BAR Meeting
October 7, 2015

ISSUE: Permit to Partially Demolish/Capsulate and Certificate of Appropriateness for alterations and new construction

APPLICANT: Sienna Corporation

LOCATION: 3640 Wheeler Avenue

PROPOSED STRUCTURE - FRONT ELEVATION

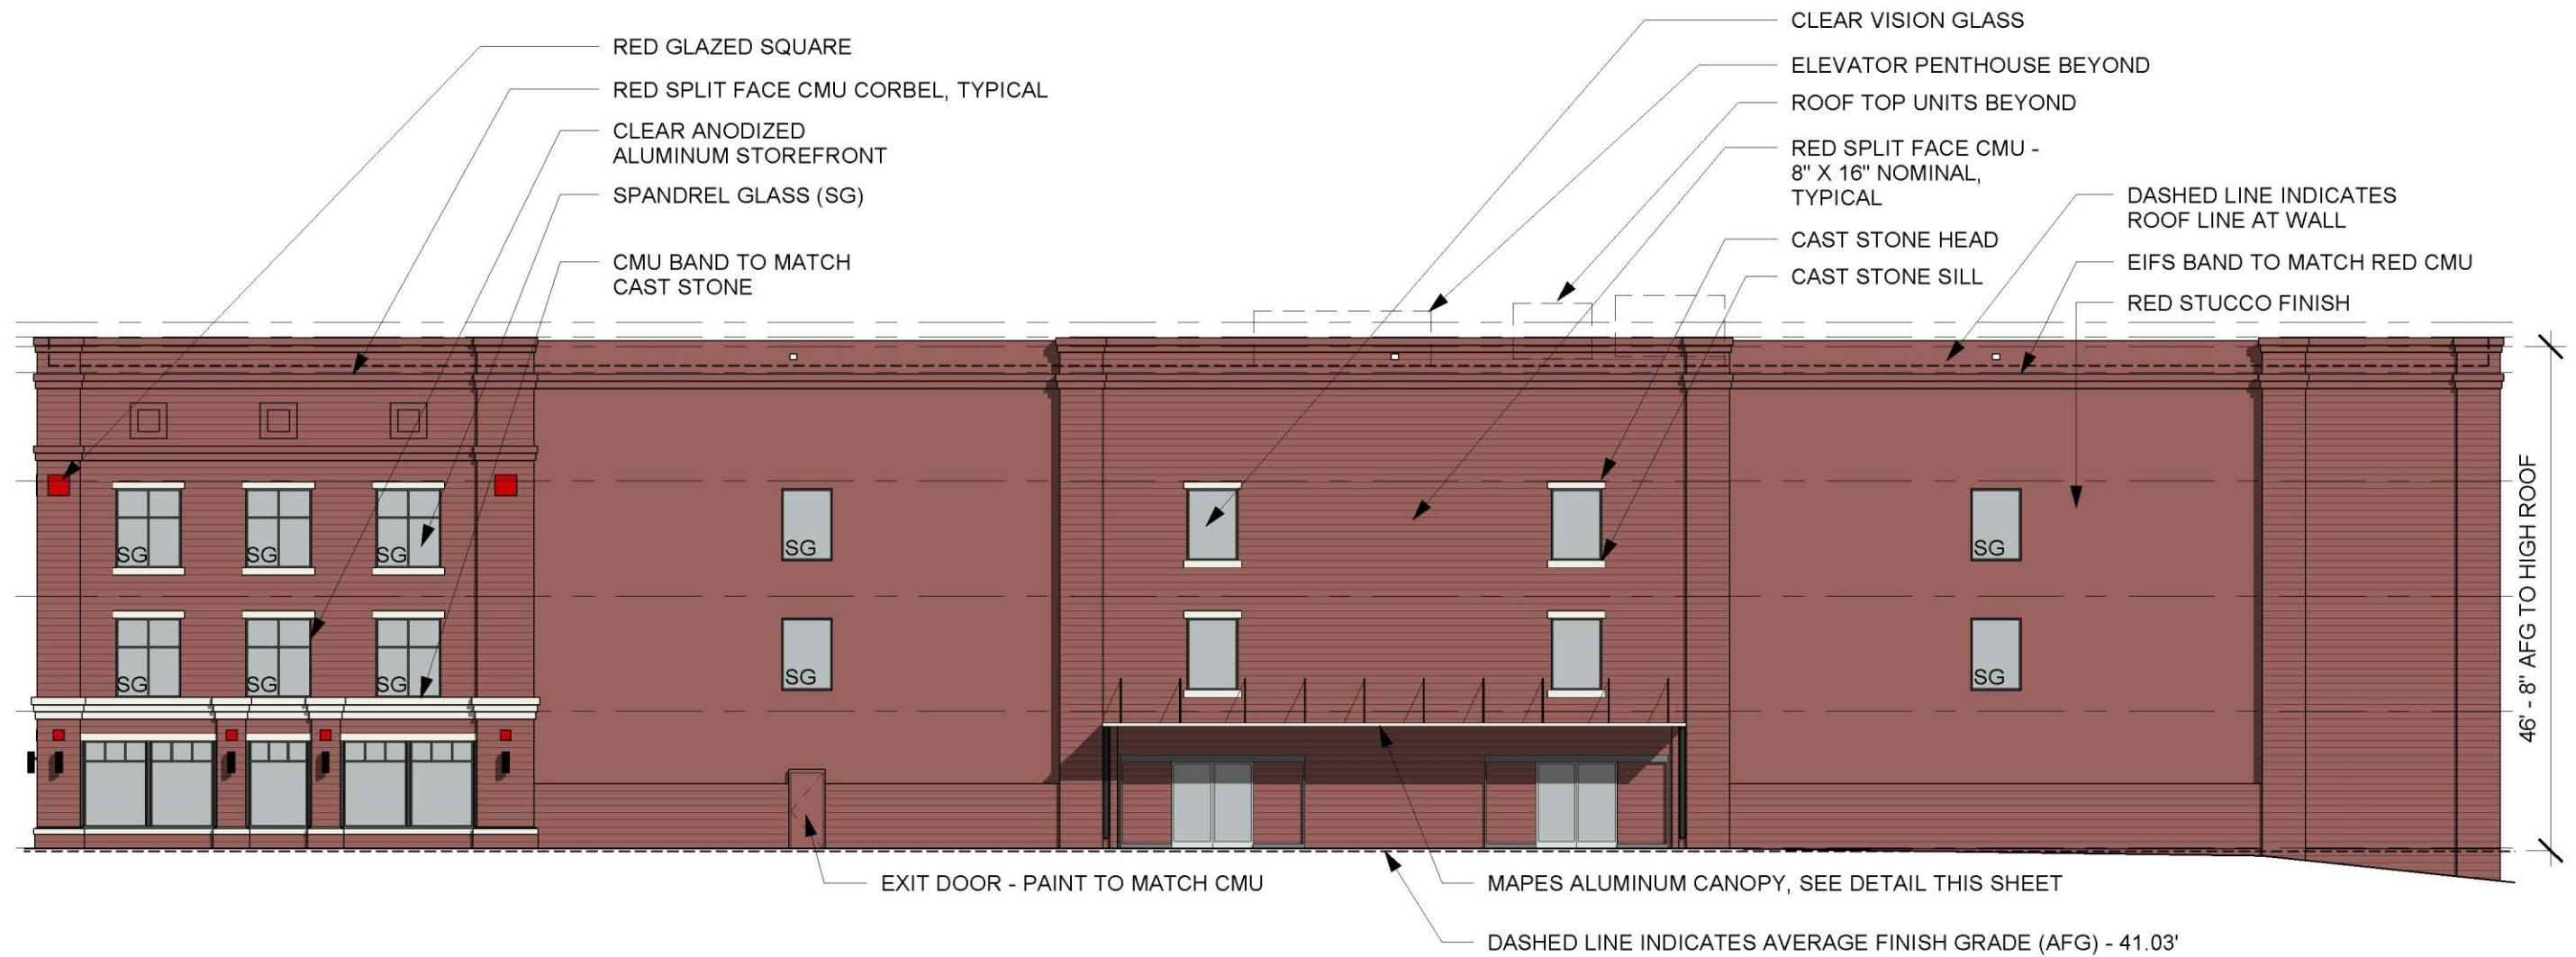
5. That the arched windows remain on the third floor of the new building as shown on the submitted plans; and,
6. The applicant work with P&Z and Alexandria Archaeology staff for final review of the graphics and text for any interpretive panels, consistent with the City's Wayfinding Program.

HISTORIC STRUCTURE - FRONT ELEVATION

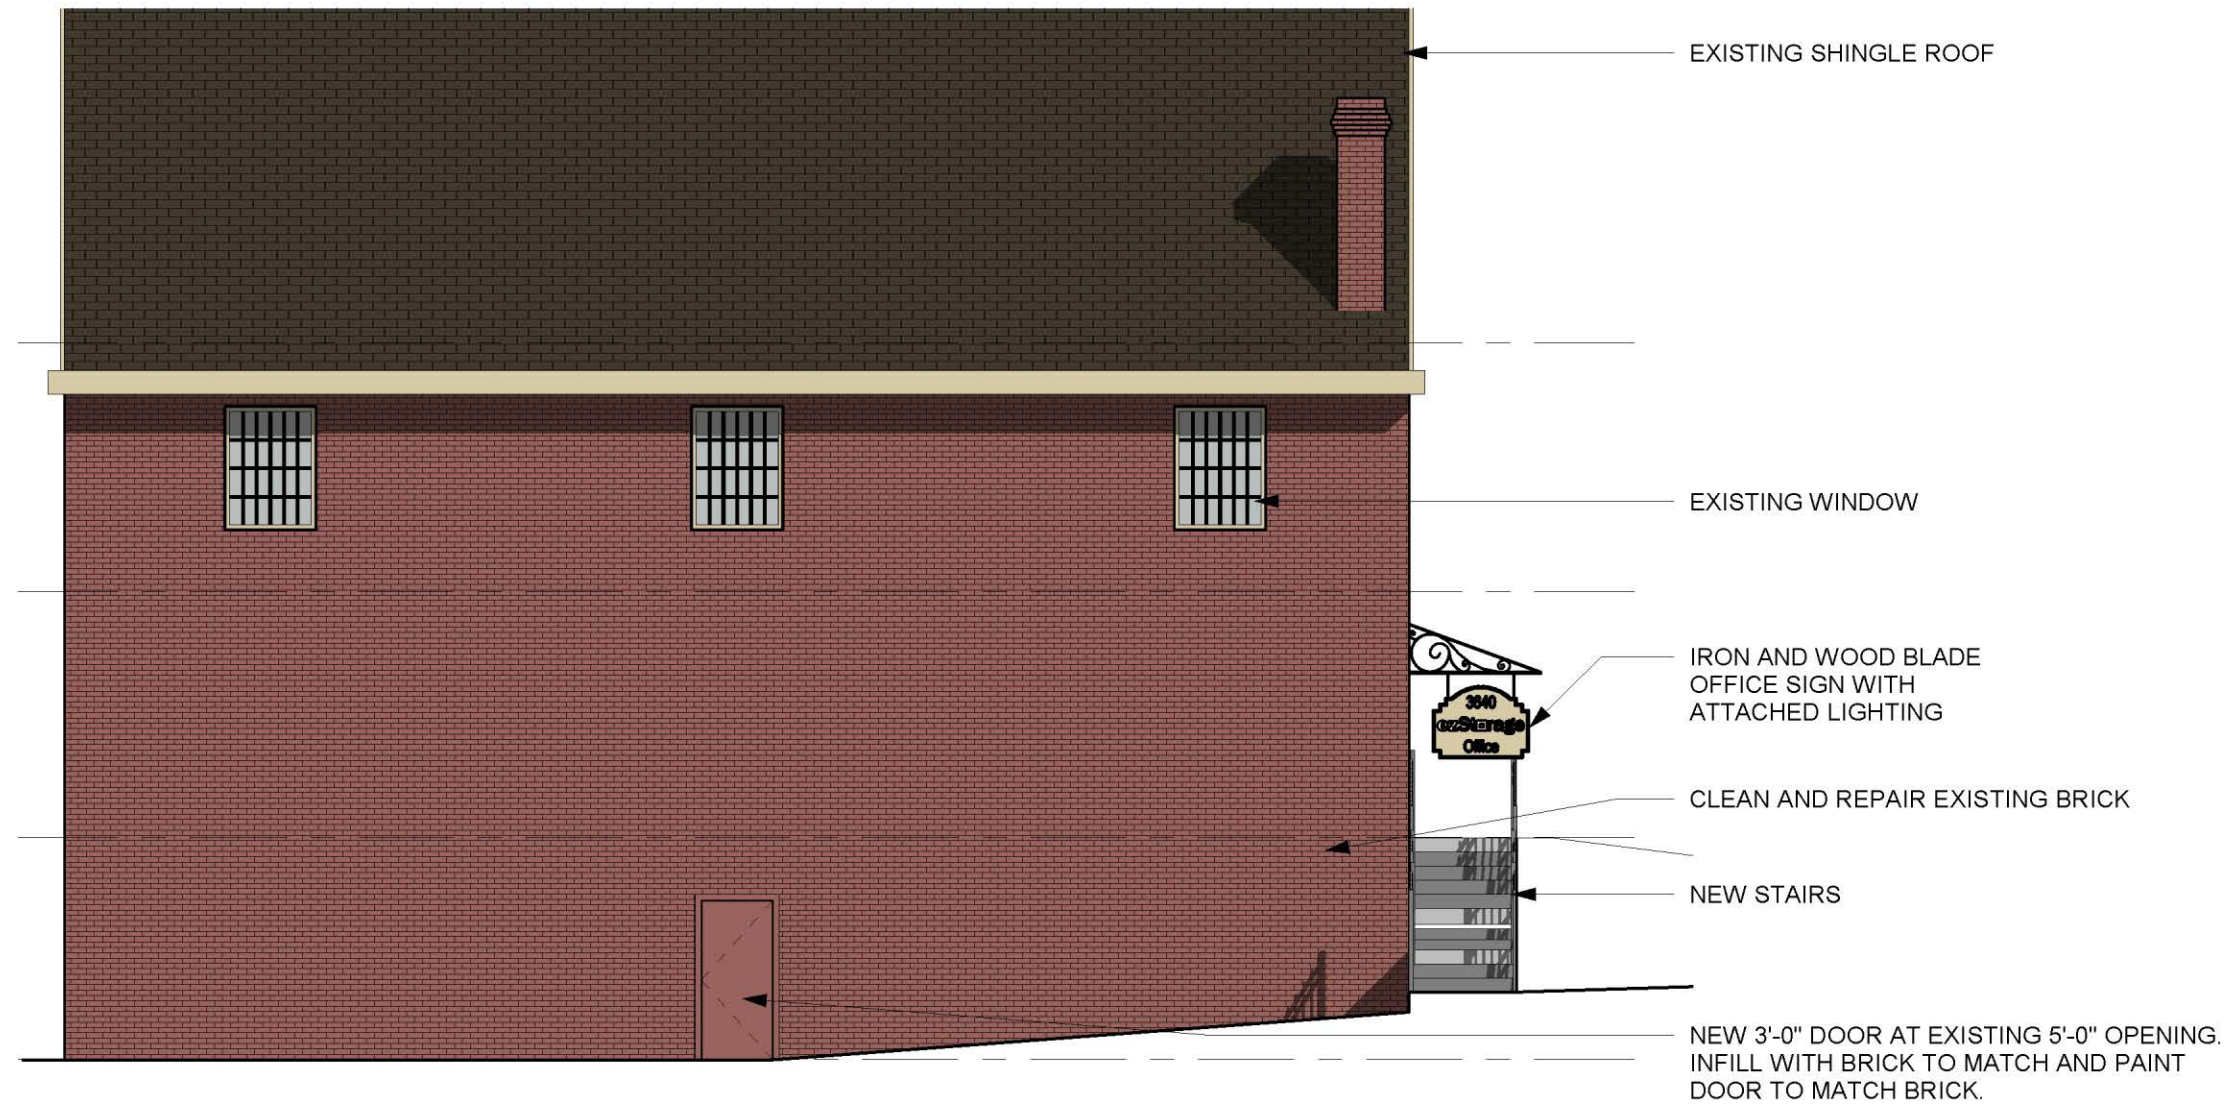
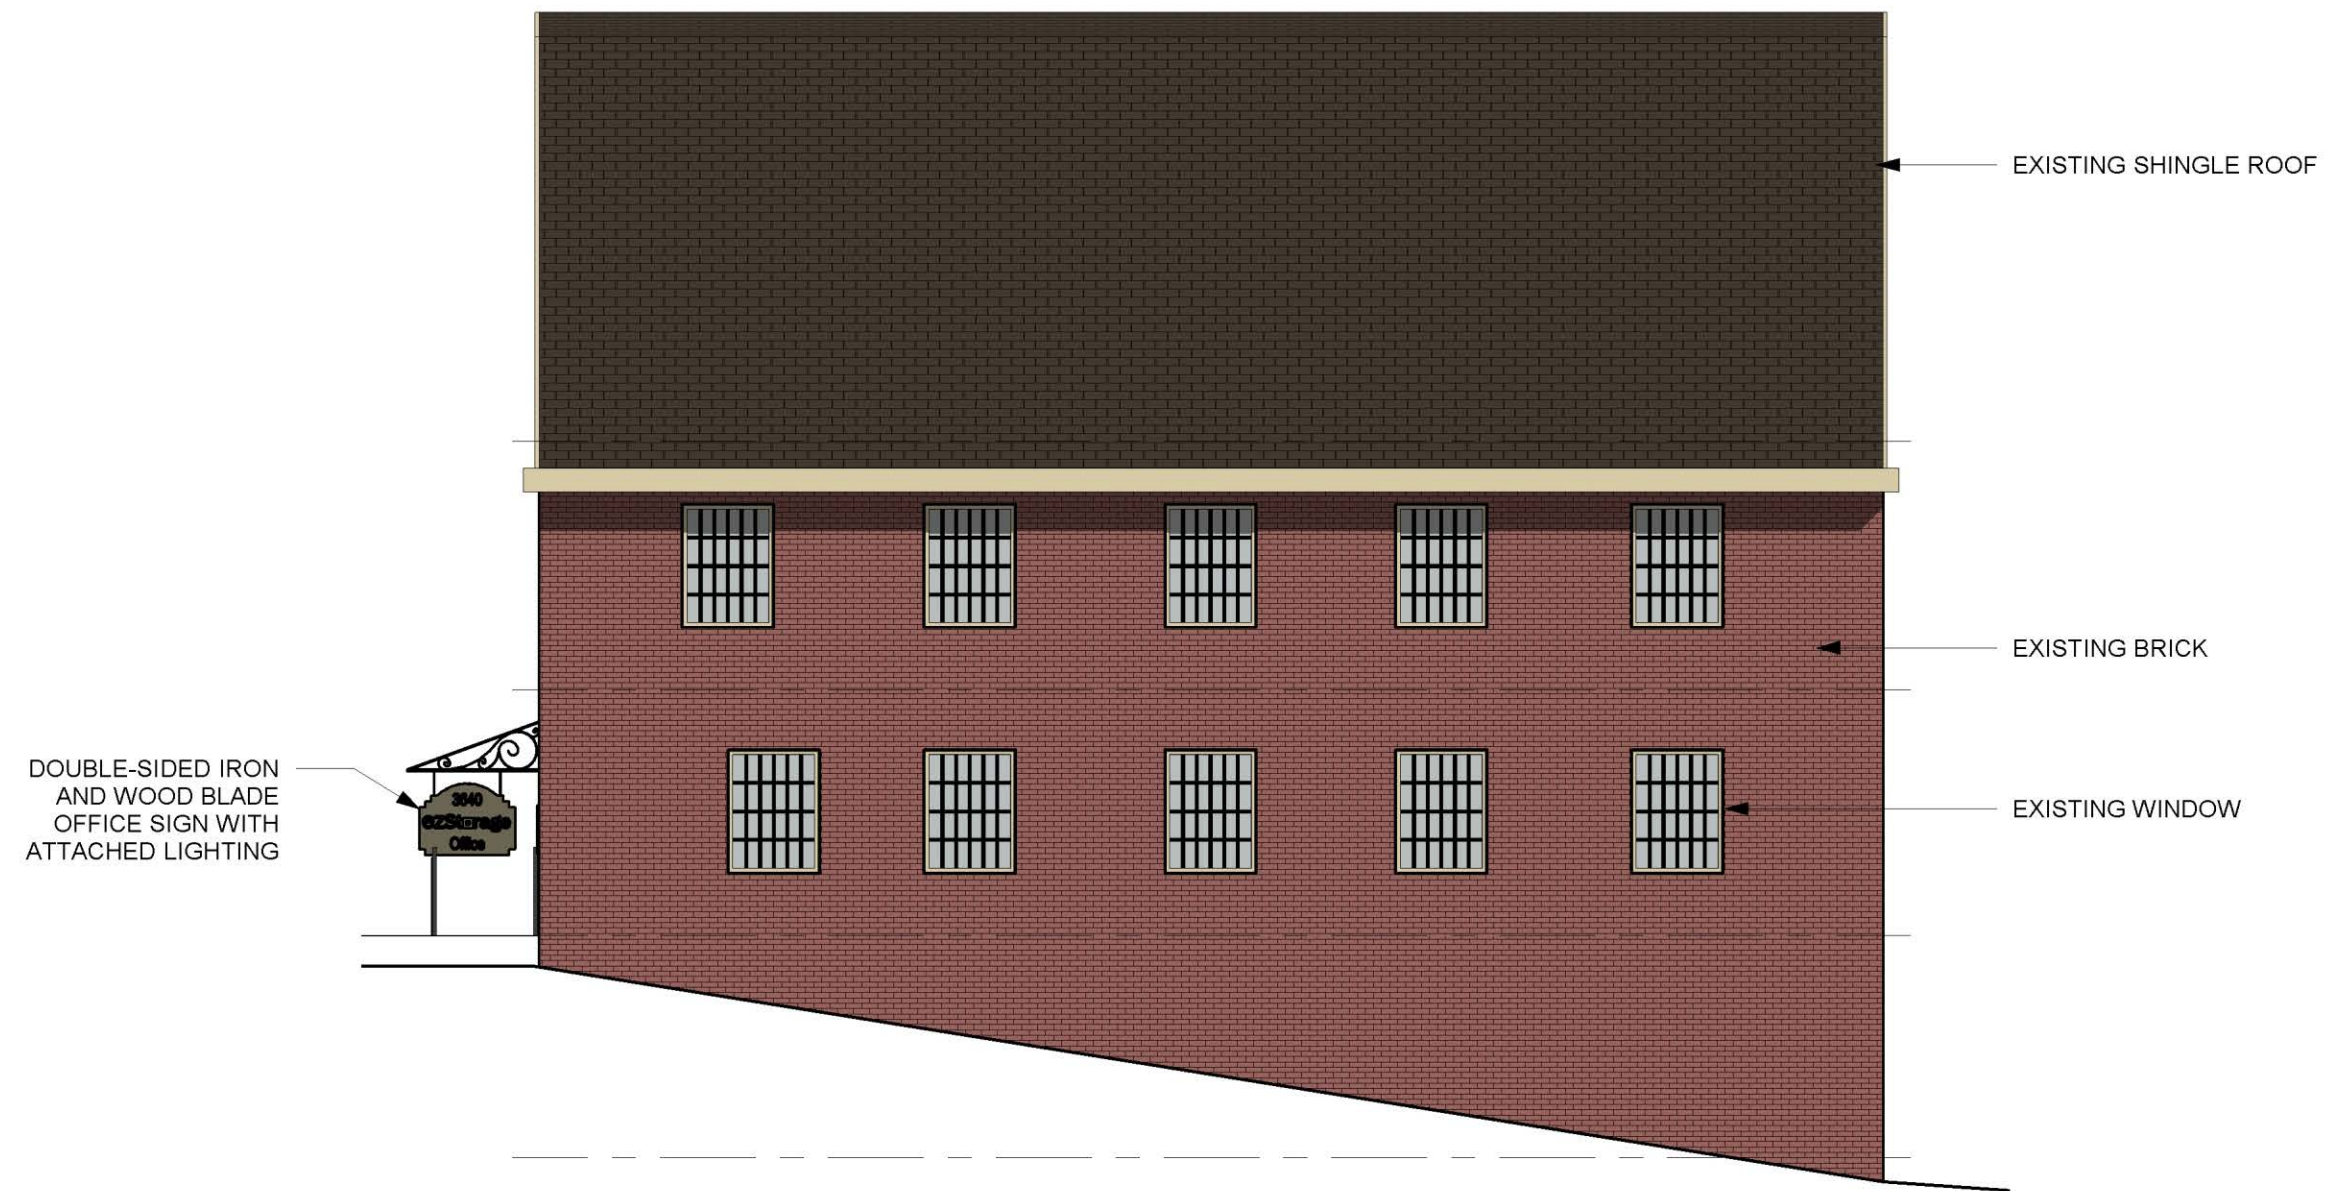
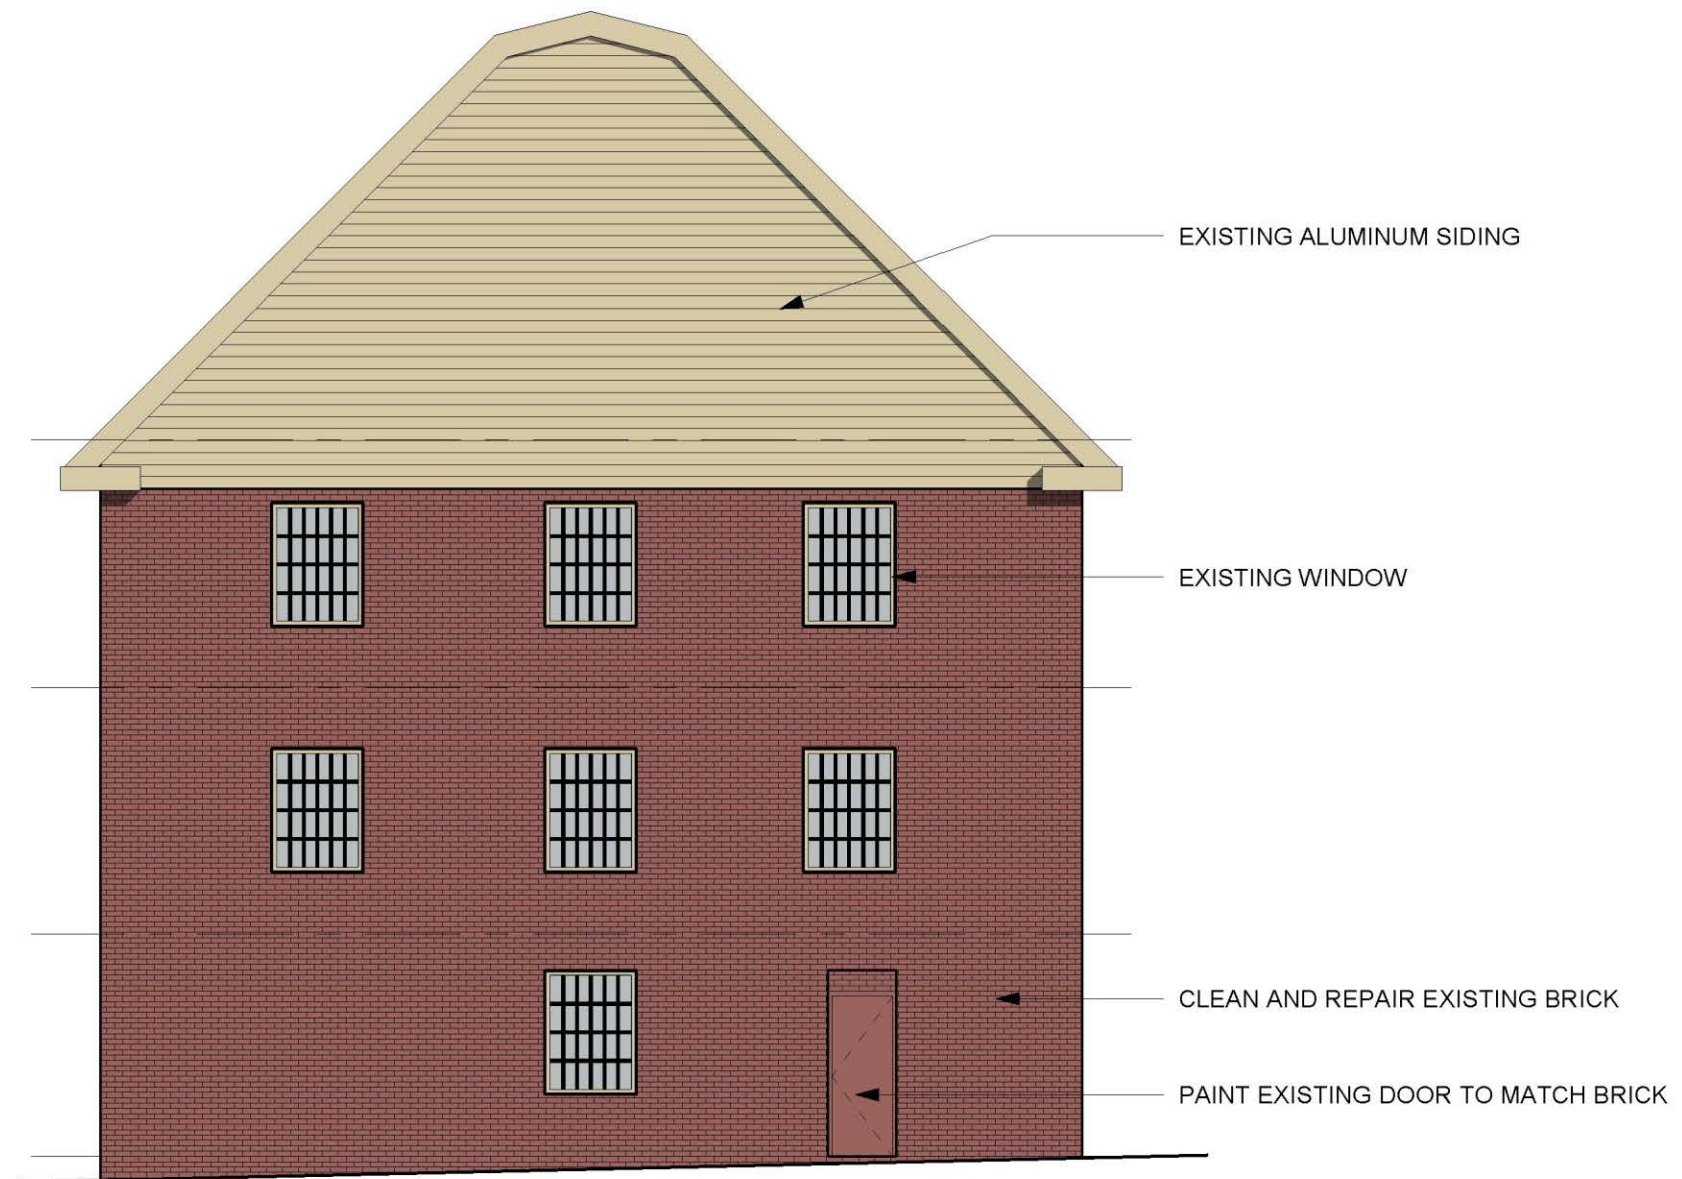
1. The applicant consult with Staff after the removal of the aluminum siding on the gambrel ends of the mill to determine if any historic fabric remains and whether it is salvageable, with final approval by Staff;

2. The applicant consult with Staff on the appropriate wood siding to be installed on the gambrel ends of the historic mill, if historic siding does not exist or cannot be salvaged;

After the aluminum siding is removed, the applicant should contact BAR Staff to inspect the gambrel ends to determine if any historic material remains. Staff will also provide guidance on the appropriate wood siding, profile and width, to use there should there be no historic material. In addition, because the applicant has not provided a manufacturer's cut sheet for the proposed new front door, or shown any lighting on the building, it is recommended that the applicant consult with Staff for final approval prior to ordering these products to ensure they are historically appropriate. Finally, as the applicant undertakes the cleaning, repair and repointing
